Item 4.**Section 4.55 Application: 169-183 Liverpool Street, Sydney - D/2019/992/A**

File No.: D/2019/992/A

Specifically, the modification seeks to amend the width of the through-site link at ground level from 10m to 18m in the 'Urban Room' and 6m at the southern extent, include articulation zones on facades, for changes to the Liverpool Street setbacks, and for changes in levels.

Figure 3: Proposed axonometric drawings

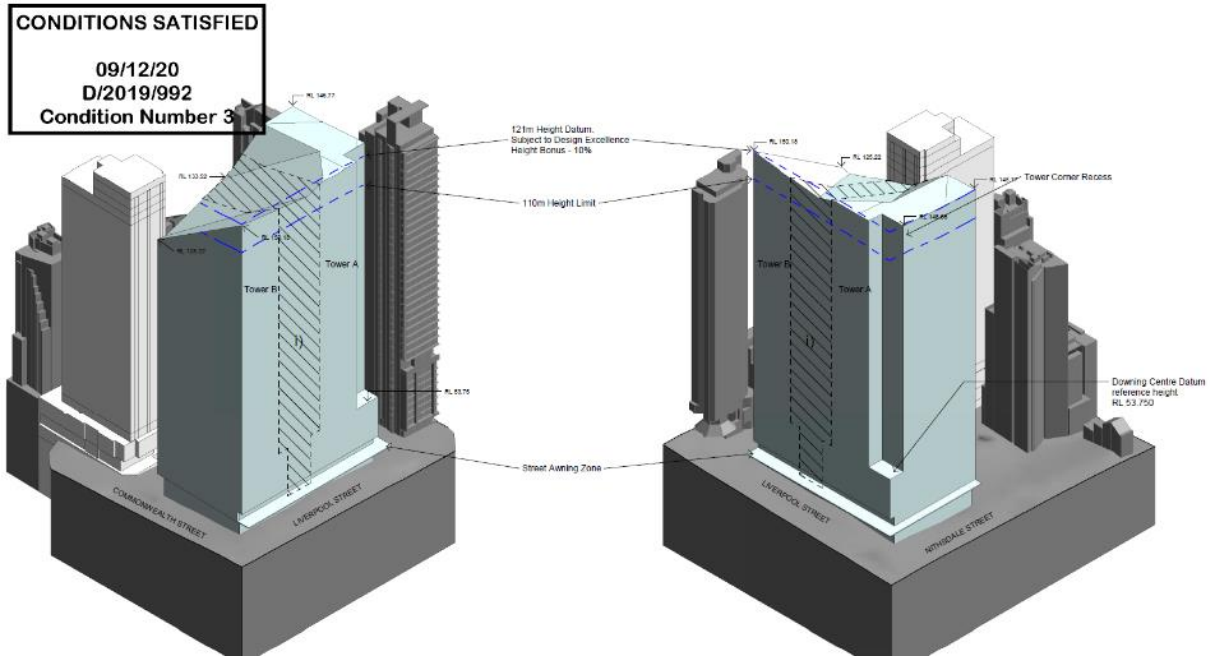
11. The subject Section 4.55(2) modification application proposes to amend the concept development consent (D/2019/992) to ensure consistency with the concurrent detailed design development application (D/2022/614).
12. Specifically, the application seeks to modify Condition 2 'Approved Development' to amend the approved architectural plans referenced in the consent, with the plans including the following:
 - amend the width of the through-site link at ground level from 10m to 18m in the 'Urban Room' and to 6m at its southern extent connecting through to Clarke Street;

- inclusion of articulation zones on the facades;
- changes to the Liverpool Street setbacks; and
- changes in levels.

Figure 7: Proposed ground floor envelope plan

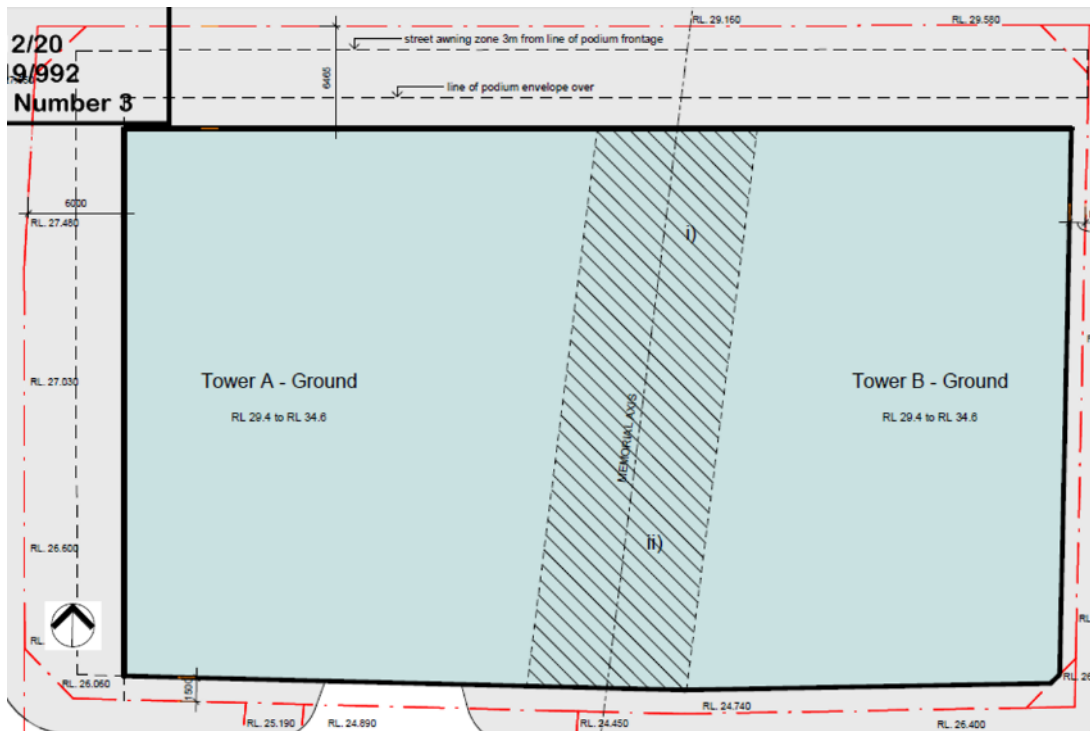
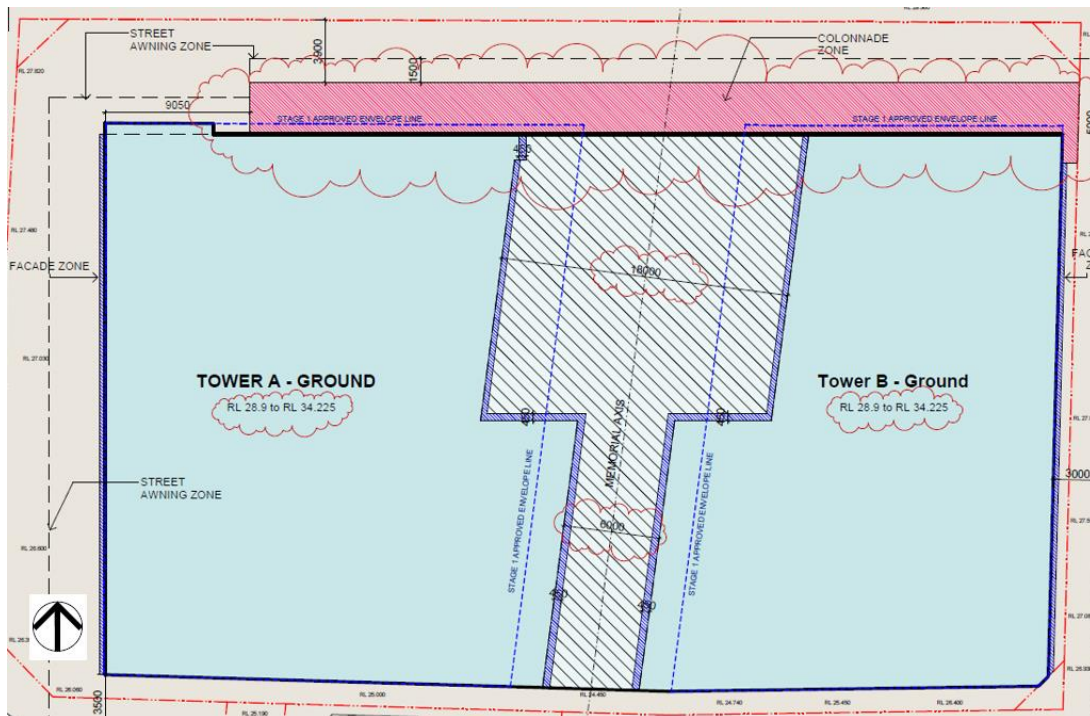
31. As part of the concept approval, an indicative through-site link was shown on the plans, separate to the approved envelope and building massing. This indicative through site link was shown to be 10 metres in width at the ground floor level and podium levels (as shown in Figure 6 below), and 18 metres in width for the tower levels.

32. The winning design competition scheme included changes to the width of the through-site link, with the provision of an 18m wide section at its northern frontage towards Liverpool Street from the ground and podium levels (known as the 'Urban Room'). The rationale for the increased width is:

- (a) consistency with the 18m separation of the towers above;
 - (b) consistency with the Anzac Memorial axis;
 - (c) assists to address wind issues on the site; and

- (d) create a strong urban response to the ground plane.
33. In addition, it is proposed to reduce the through-site link width to 6m towards the Clarke Street interface of the site, to reflect a more fine-grain form and laneway representative of the historical character of Surry Hills.

34. The subject modification application proposes to amend the through-site link in accordance with the design competition winning scheme. For the ground and podium levels, it is proposed to amend the through-site link width to part 18 metres, part 6 metres, as shown in Figure 7 below. This will result in an overall increase in the approved area of the through-site link (from approximately 340sqm to approximately 390sqm), as well as the approved 10m width at ground level. The 6m dimension at the rear is also consistent with Council's requirements for through site links as set out in Section 3.1.2.2 of the Sydney DCP 2012, which specifies a minimum width of 4m or 6m where bike access is provided.

- (i) The proposed modification seeks to amend the Liverpool Street setback at upper ground level and level 1 in the concept envelope (shown in pink on the proposed envelope plans at Figure 7), to accommodate a colonnade in this location for the detailed design development application. The amended setback to Liverpool Street will be consistent with the Liverpool Street setback for the levels above.

35. Council Officers support the proposed amendments to and rationale for varying the width of the through site link.

Figure 8: Proposed tower levels (7-28) concept envelope plan

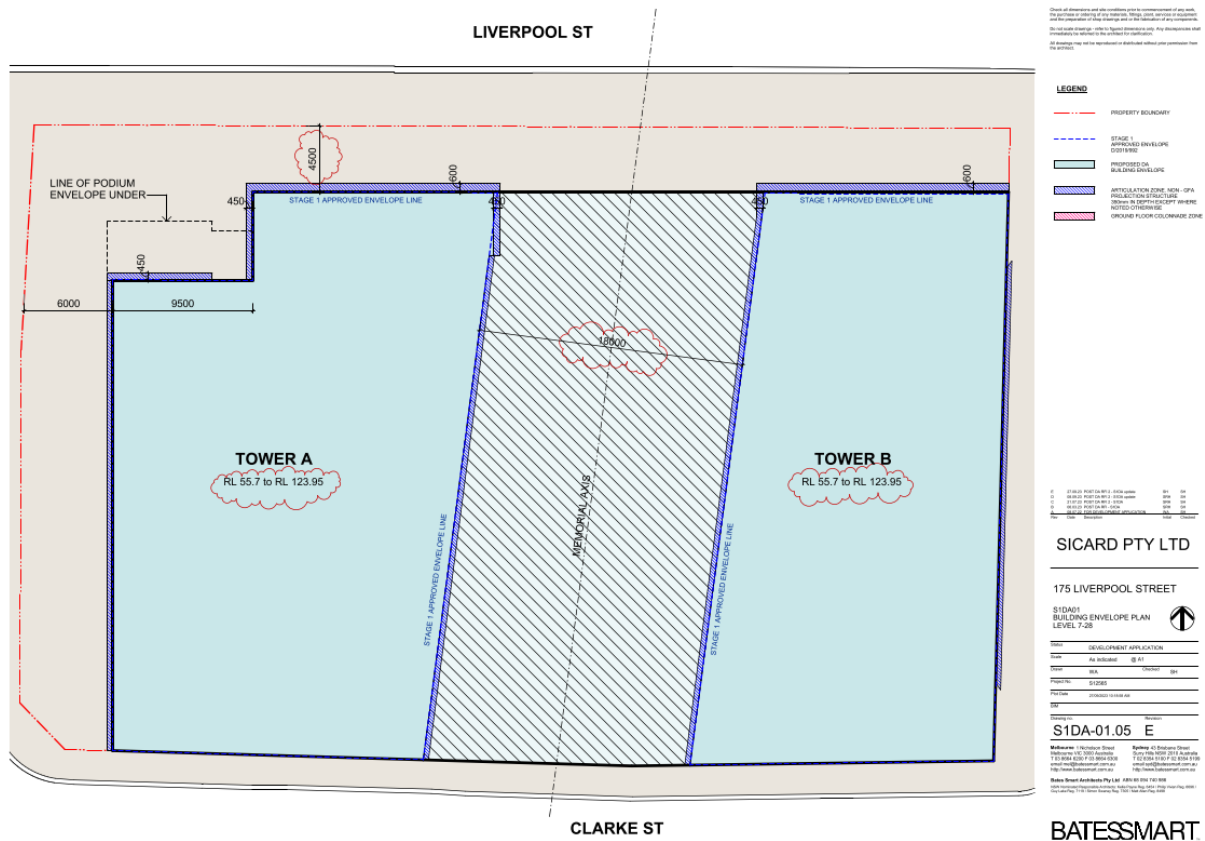
36. The subject modification application proposes minor extensions to the envelope to capture the detailed facade design of the building, with the architectural elements in these zones to provides privacy and shading fins, as well as horizontal concrete lintels to support these elements. These are identified as 'articulation zones' on the modified concept envelope drawings at Attachment B and as shown in Figure 8 below.

- 37. These articulation zones are contained within the site boundaries, except for the site's eastern frontage to Commonwealth Street.
- 38. Schedule 4 of the Sydney DCP 2012 allows for projections beyond private property boundaries over or into the public road/footpath, as follows:
 - (a) Projections for decorations or sun shading devices: A maximum projection of 450mm, at least 3m above the footpath, at least 800mm from the face of the kerb, and being constructed primarily of masonry, reinforced concrete, steel or other approved non-combustible material.
 - (b) Projections for balconies and bay windows: A maximum projection of 450mm, not comprising more than 50 per cent of the road frontage, at least 3.2m above the footpath, at least 800mm from the face of the kerb, and does not result in adverse impacts on the amenity of the adjoining property.

40. The proposed articulation zone over the Commonwealth Street site boundary is generally consistent with the above requirements, and is acceptable for the following reasons:

- (a) It includes projections for sun shading devices / privacy fins and bay windows of 350mm in depth, which is less than the 450mm maximum projection specified in Schedule 4 of the Sydney DCP 2012.

- (b) The articulation zone commences from level 1, which is higher than the 3-3.2m heights specified in Schedule 4.
 - (c) The articulation zone is not within 800mm from the face of the kerb, as specified in Schedule 4.

- (d) The shading devices / privacy fins comprise a bronze finish metal, which is non-combustible material, as required by Schedule 4.
 - (e) Although the projection comprises more than 50 per cent of the road frontage, it does not extend the full length of the building elevation, with the northern most extent of the facade closer to Liverpool Street being contained within the site boundary.

- (g) The frontage to Commonwealth Street has a width greater than 8m, as required by Section 5.1.4 of the Sydney DCP 2012.
 - (h) The articulation zone does not derogate from the existing daylight levels in Commonwealth Street, with the zone being reduced from 450mm to 350mm to address the DAP's concerns regarding this.

- (i) The projections do not contain GFA.
 - (j) The articulation zone is more than 10m away from the Liverpool Street and Commonwealth Street intersection. Less than 10m has been provided for the Commonwealth Street and Clarke Street intersection, however this is acceptable in this circumstance given there being less traffic going through these side streets.
